FCC ID: **YZZGXP2140**

TO: Federal Communication Commission

Please be notified that we, the undersigned, Grandstream Networks, INC. use two different main board for this device, V1.4A and V1.5A, and differences are listed in below:

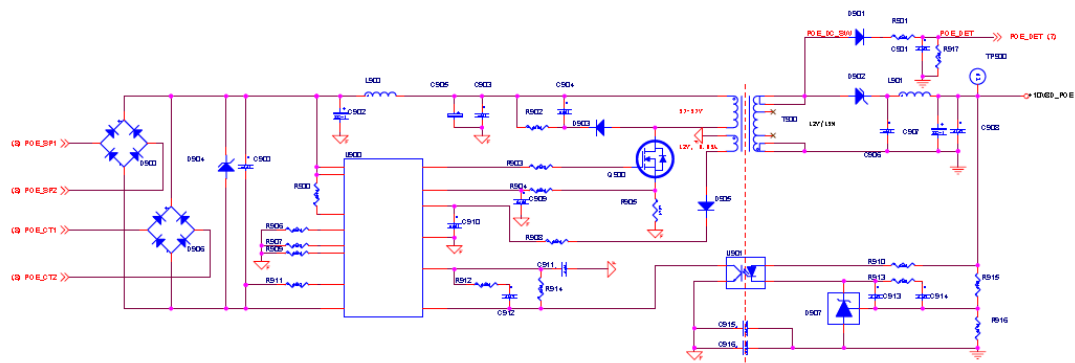
1. The GXP2140_V1.5A schematic only change the POE circuit. We add the RC filtering circuit (see arrow A,B,C,D) for improve power ripple and EMI.

1. Add R918 100-ohm, C918 330Pf /200V for improve EMI (See arrow A)
2. Add an optional circuit. R919 33(DNI) C922 1000Pf/50V(DNI) (See arrow B)
3. Add B900 600-ohm Bead , C919 100Nf/16V for improve power ripple. (See arrow C)
4. Add C920 1000Pf/2kv(DNI) , C921 1000Pf/2kv , C915 1000Pf/2kv(DNI) for improve EMI (See arrow D)

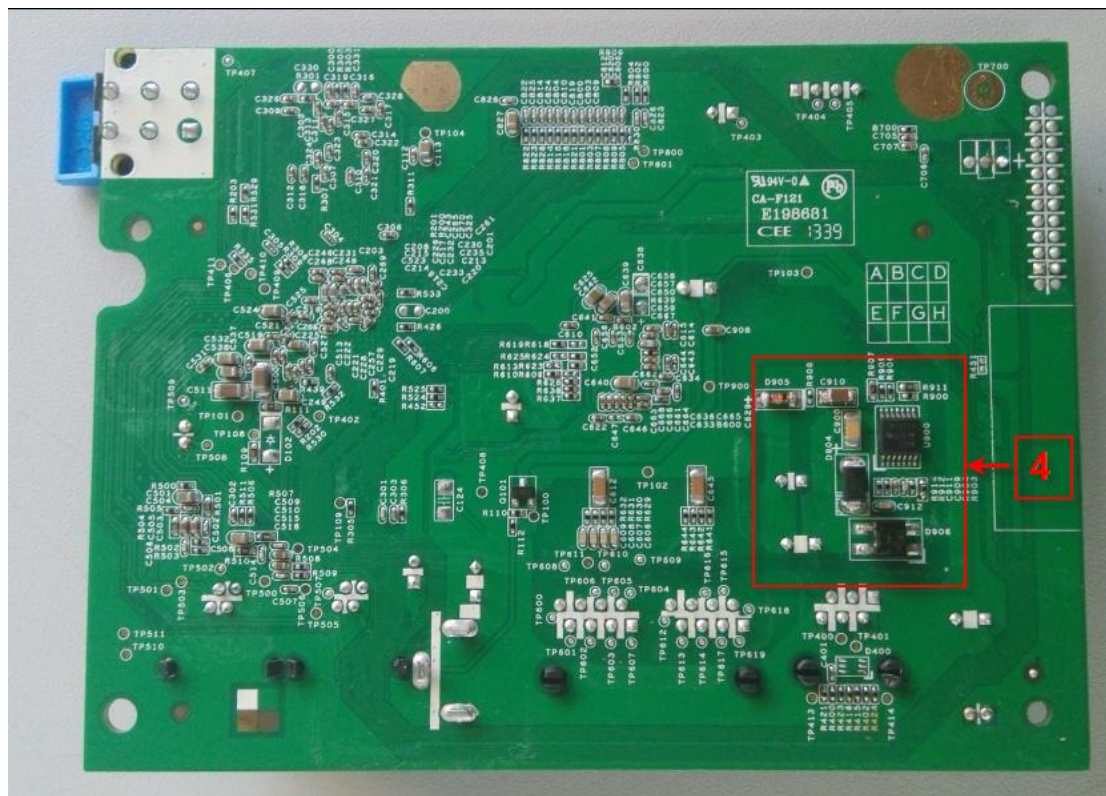
1. Two mainboard hardware version, GXP2140 V1.4A and GXP2140 V1.5A.
2. Different component layout and PCB layout (for V1.4A, plz see arrow 3 and 4 of mainboard photo view, for V1.5A, plz see arrow 1 and 2 of mainboard photo view).
